REMARKS

FIG. 3

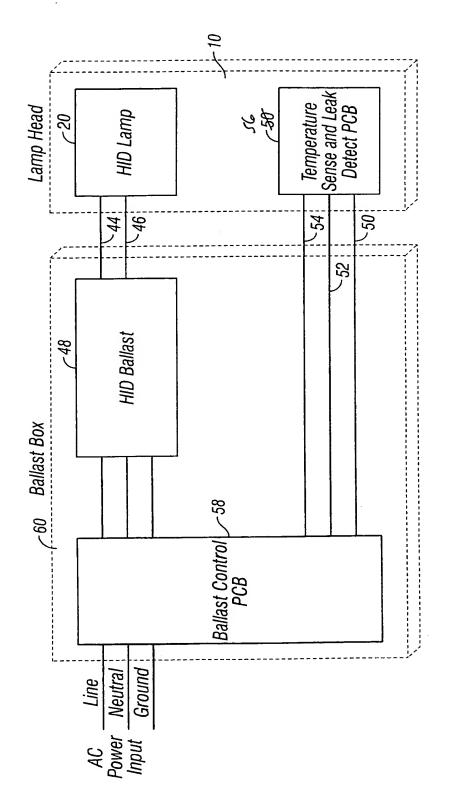
Please allow the correction of Fig. 3 by changing reference numeral 50 to 56, as suggested by the examiner and shown in red ink in the attached copy of Fig. 3. Also transmitted herewith is replacement sheet with corrected Fig. 3. No new matter has been added, as, the examiner has correctly pointed out, the temperature sense and leak detect PCB is referred to with reference numeral 56 on page 6, in paragraph 31.
